Re: Valiano Specific Plan, SCH NO. 2013061042—Public Comments on Draft Environmental Impact Report

*Valiano Project
Public Review Draft Environmental Impact Report*

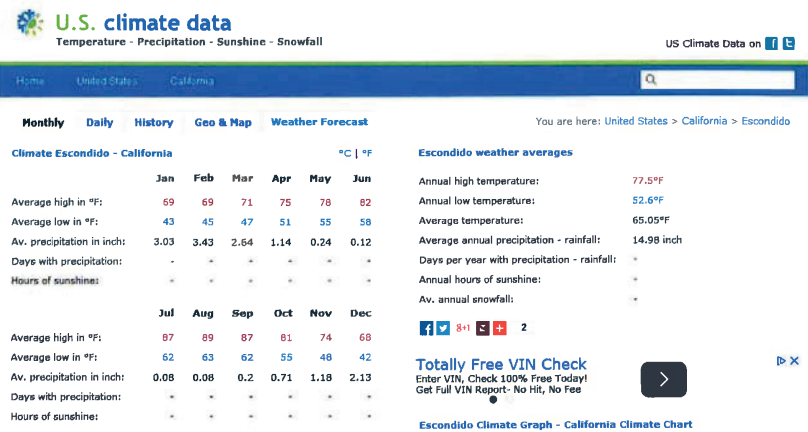
Since the nearest Sherriffs station is approximately the same distance away as the nearest San Marcos fire station, how will the Sherriff provide a faster response time than fire? I suspect that they will have the same, if not longer, response times and believe further study is needed. In addition, studies show that with more population density comes additional crime and fire risk. I see in the report that it will take the Sherriff's department just under 20 minutes to respond to

CC-47 The quoted EIR section lists average travel times based upon available records and does not state that the listed times would be the exact travel times in the future. It is possible that the Sheriff response would not be faster than the fire response. Service demand would be likely to increase with implementation of the Proposed Project, but it is anticipated that expanded police protection services would be funded, as necessary, from increased property taxes and other revenues to the County resulting from the Proposed Project. The response times from the Priority 1 call are not irrelevant; the circumstances under which that call took place were disclosed and it would be possible for an officer to be on scene or near scene for a future call.
